Planning Commission Meeting

April 12, 2022 6:00 PM

AGENDA

4.I. 3347 Myrtle Street Final Plat Review

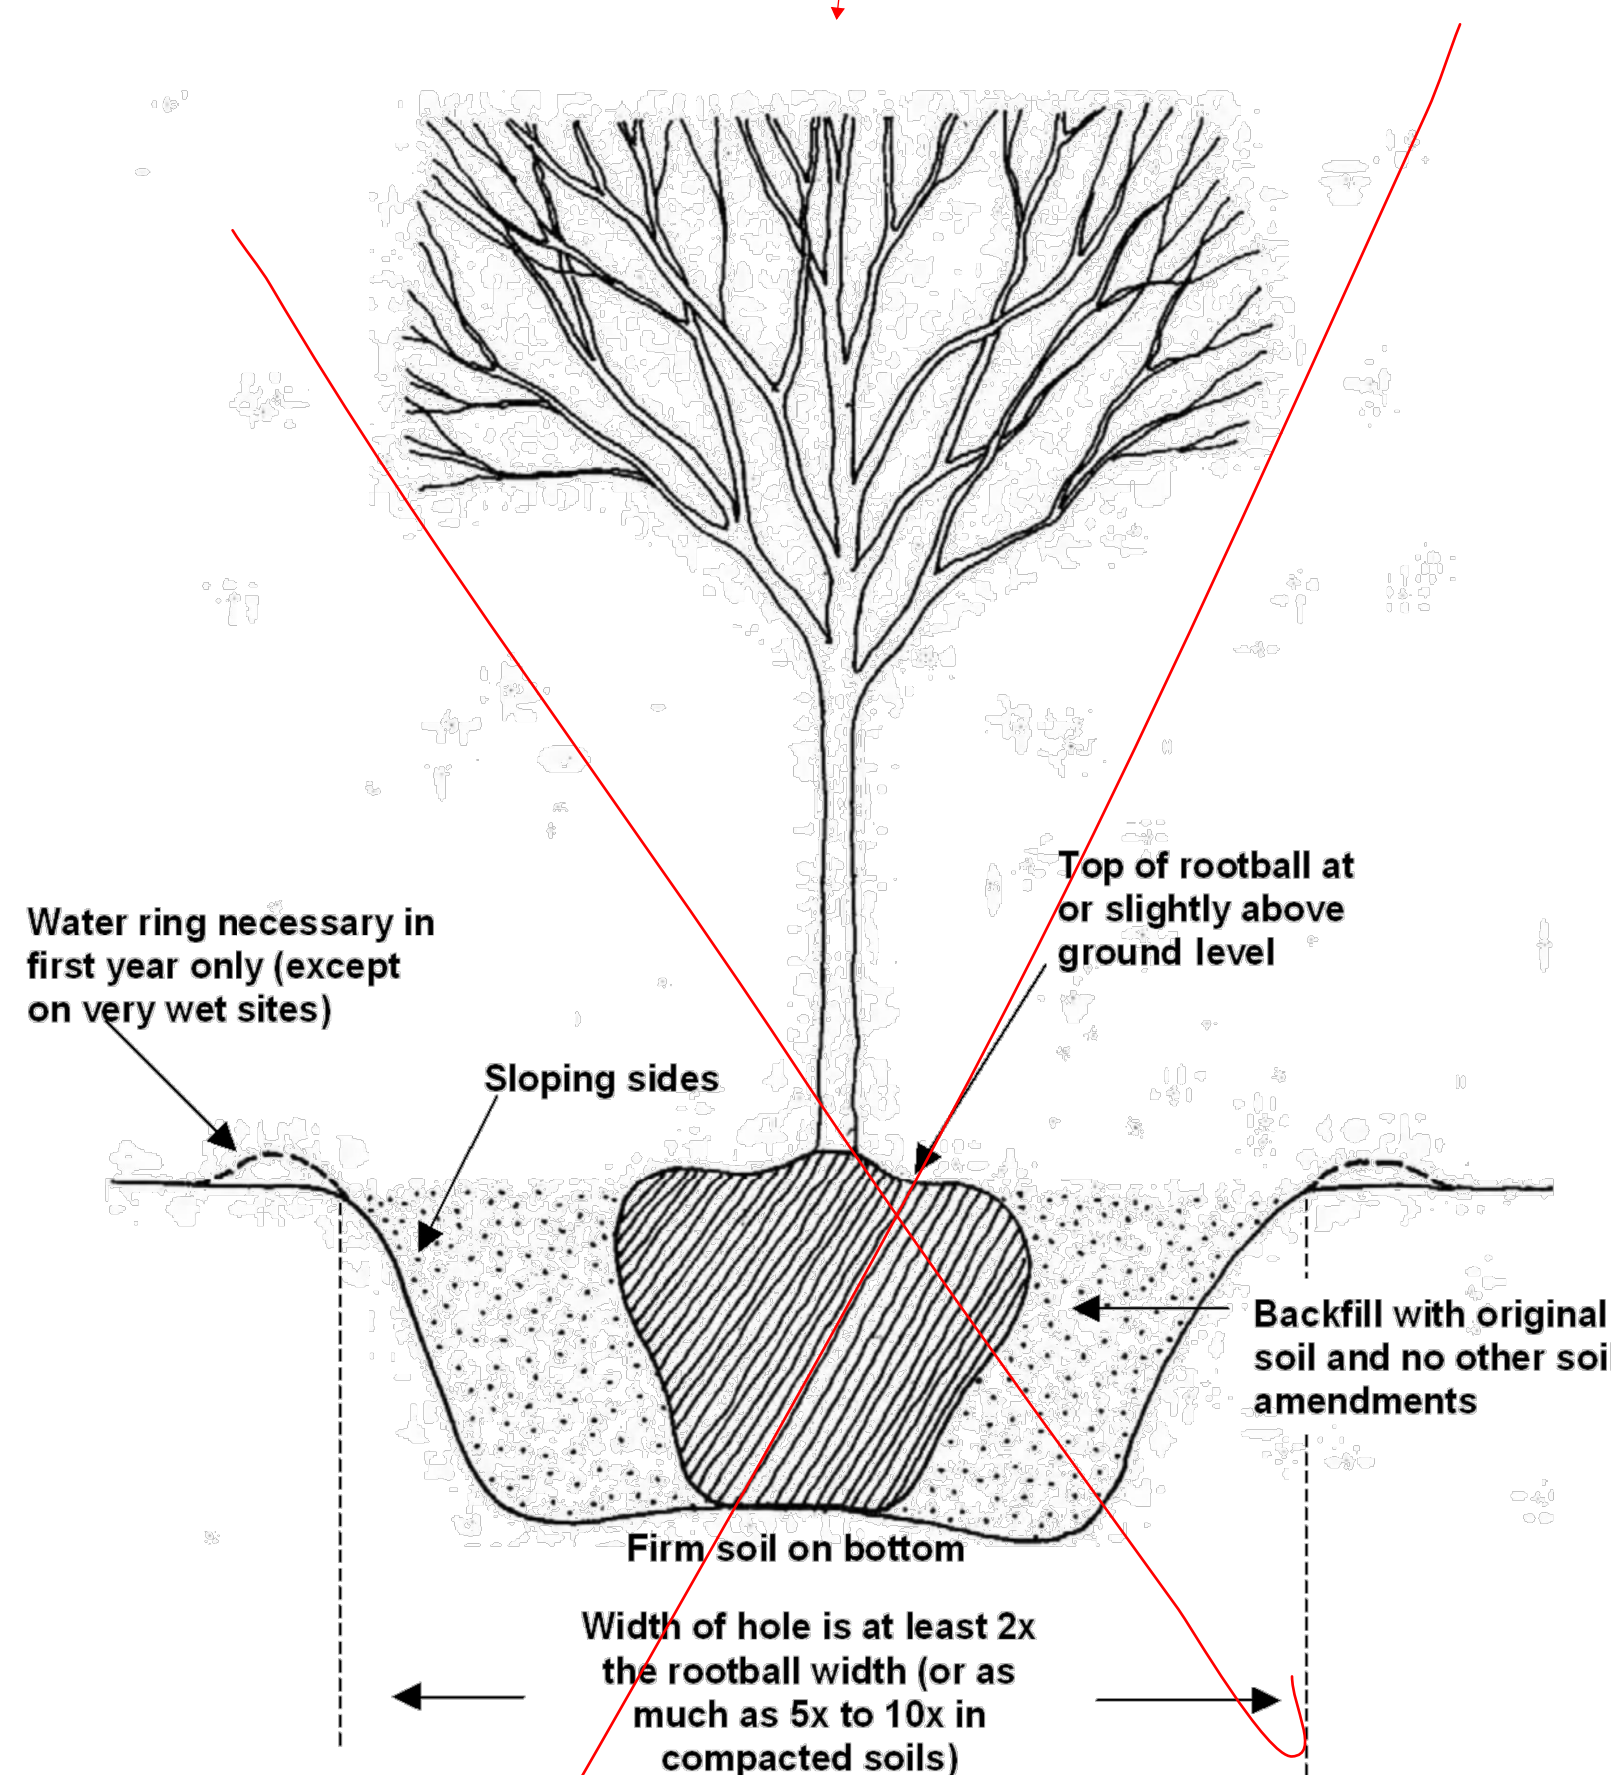
Also, per my earlier comments on this lot, it was suggested that the Planning Commission may give a variance for the recompense on Landmark Tree #2 since it is in the center of the lot which is the only ingress. Discuss with City to start the process. If approved, the cost for the 35" Pin Oak could be waived.

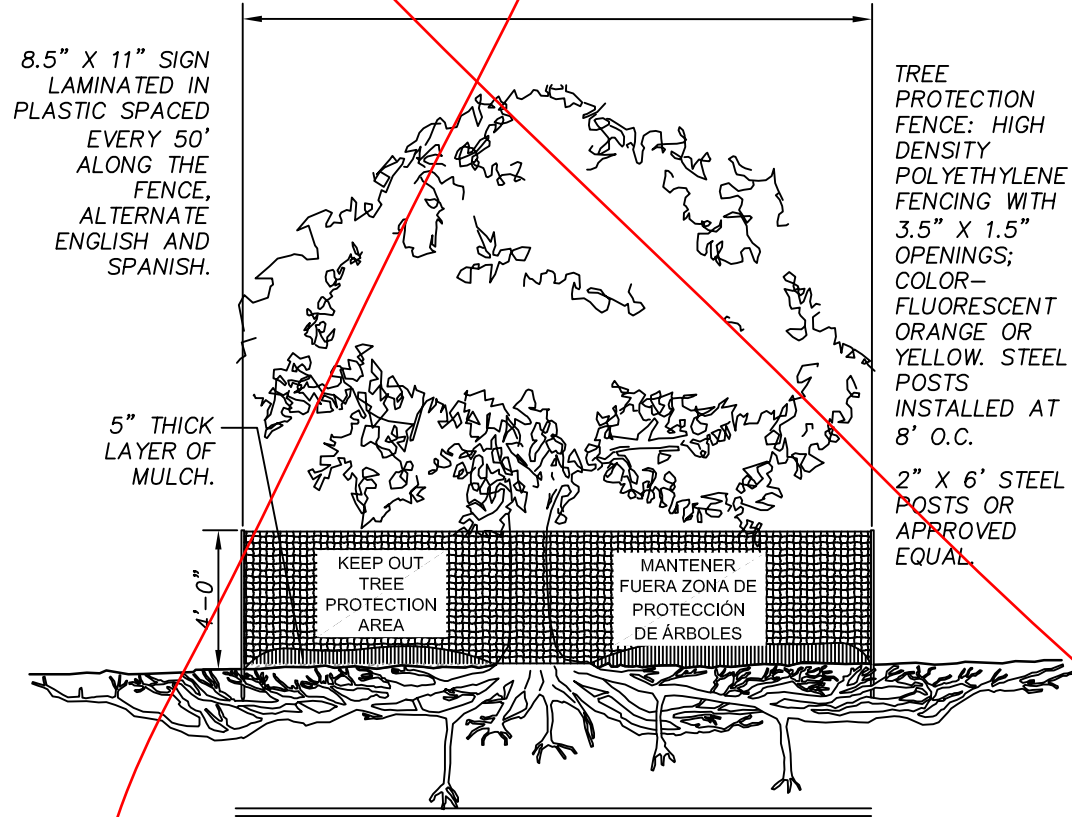
If the Arborist Report shows that tree #1 is in Good Condition, it still can't be used for credit since there is disturbance in the CRZ. In addition, is the new porch in an area that is already paved? If not it will need to be moved out of the CRZ, recompensed, or, an Arborist will need to confirm that no roots are in the area to be disturbed.

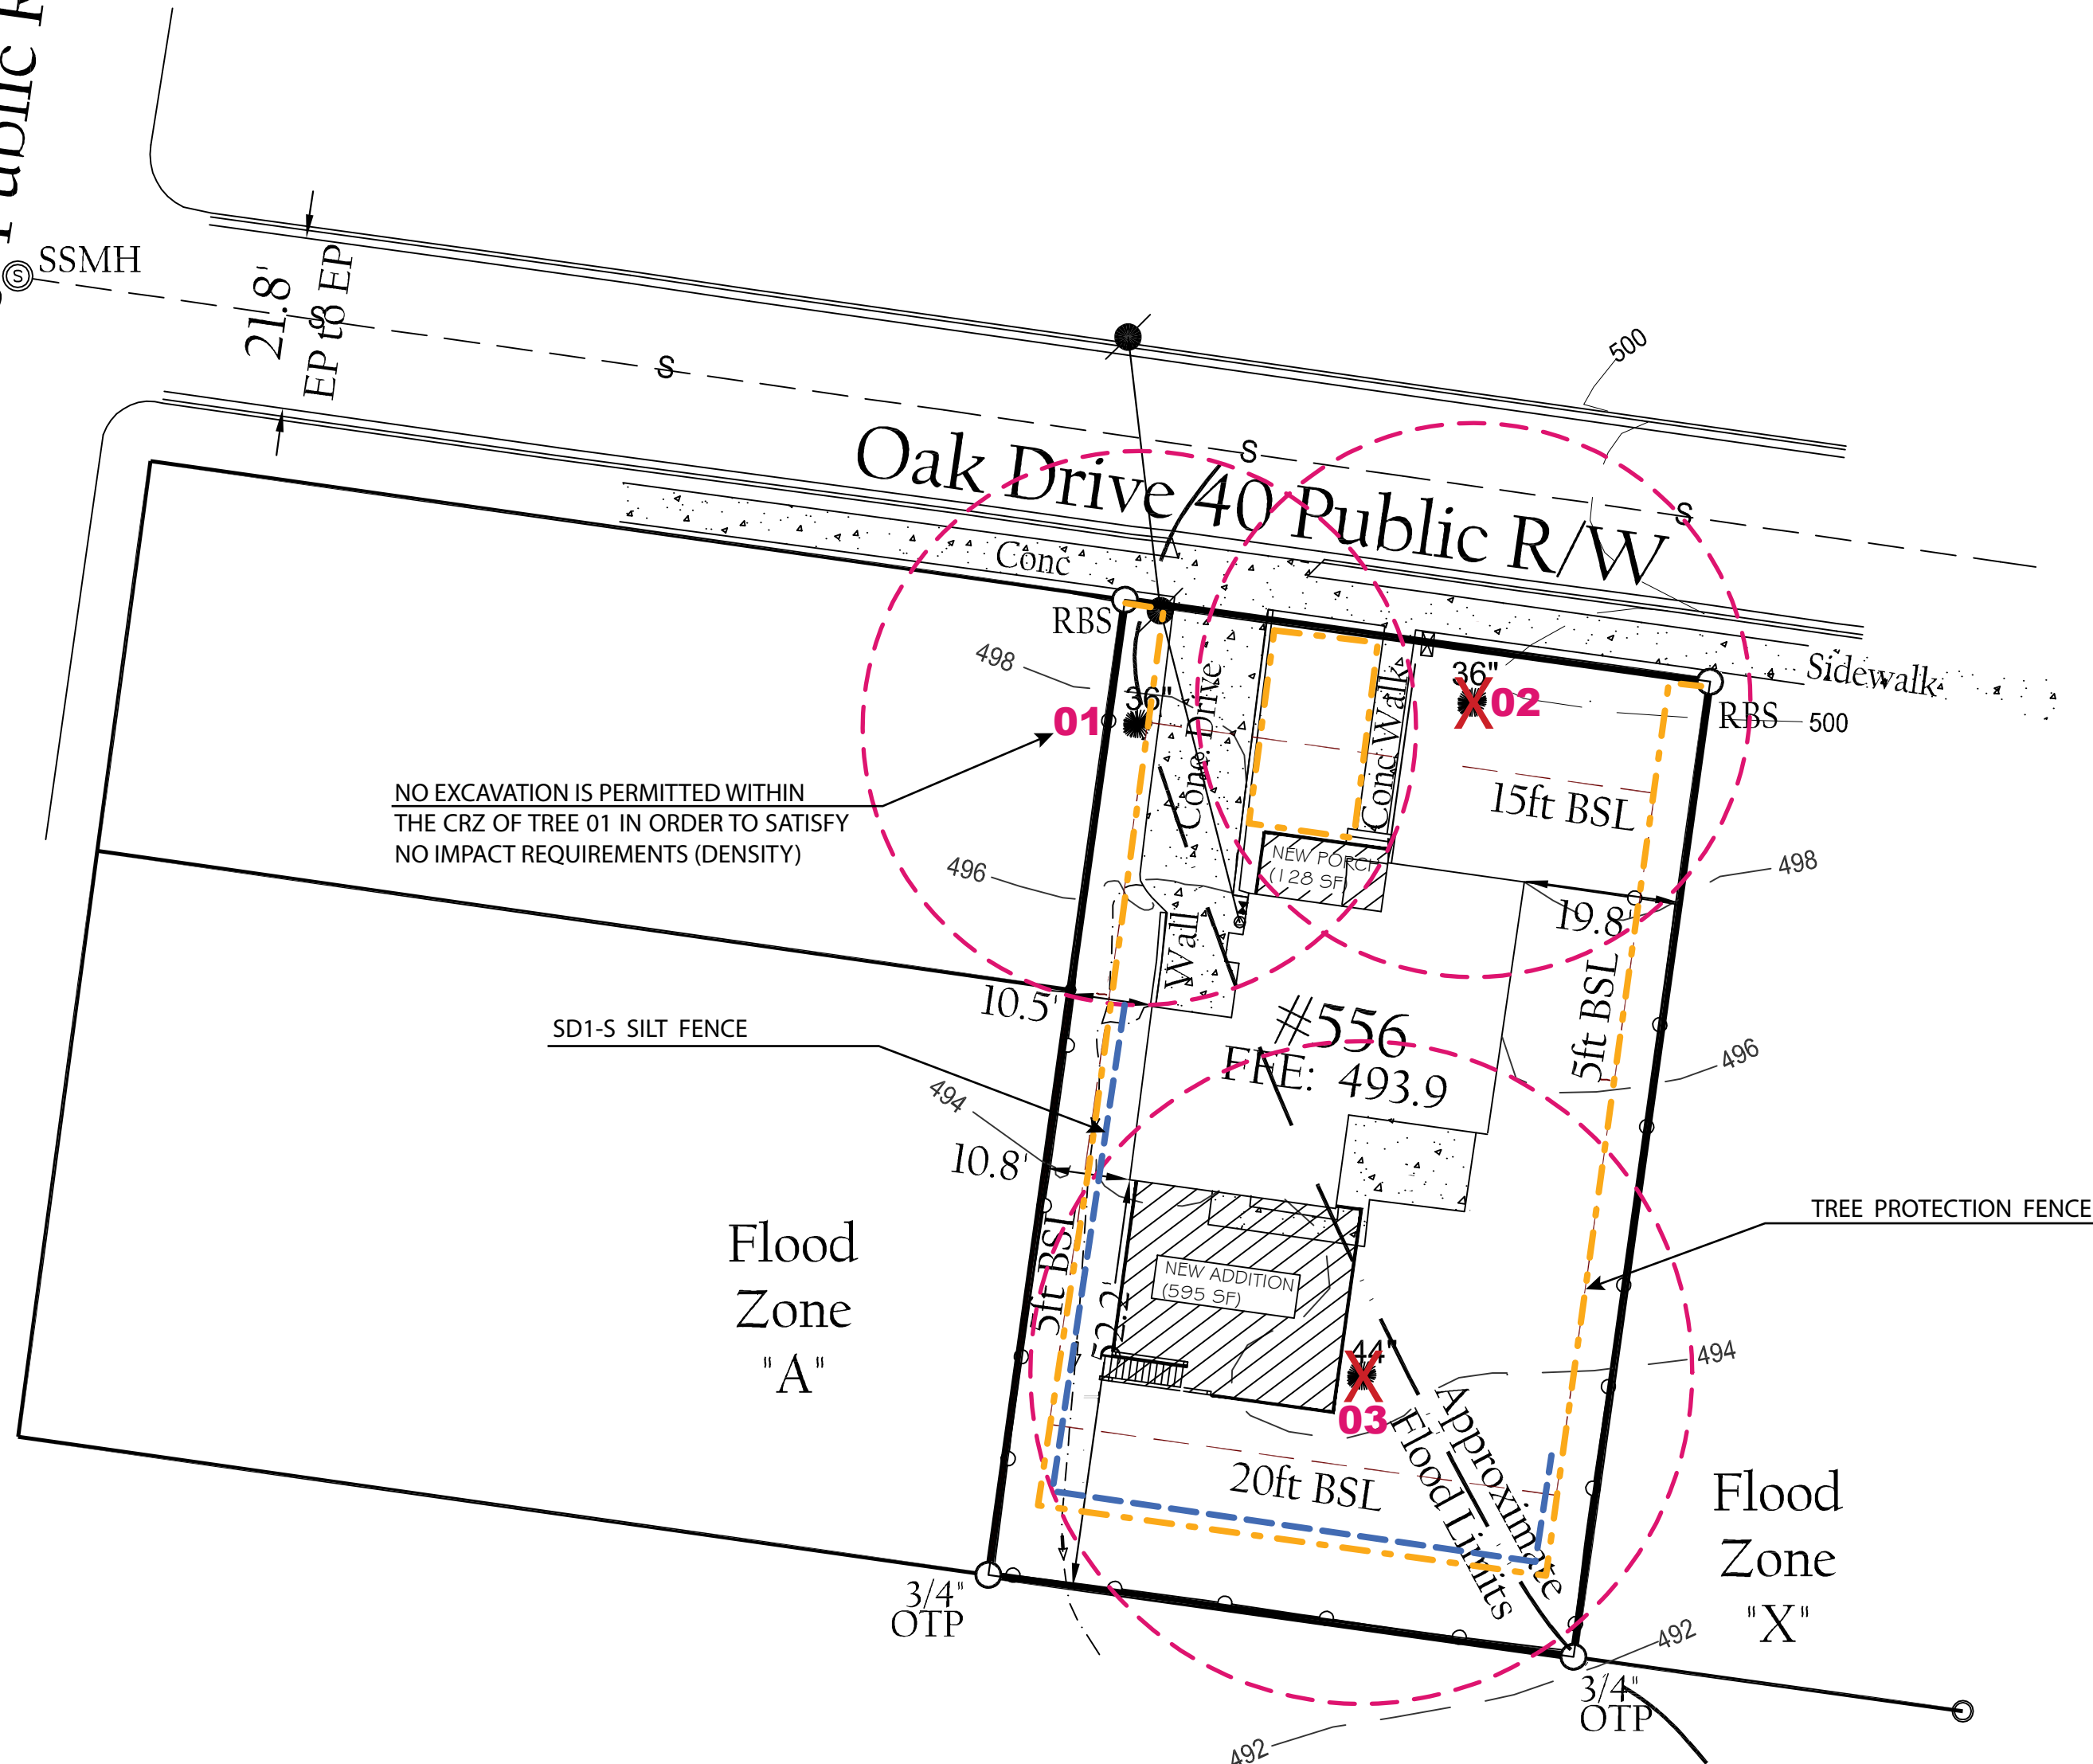
Who did this assessment?
- Include the name and ISA Certification number
The full report with photos showing the defects is/are required - this chart is not sufficient
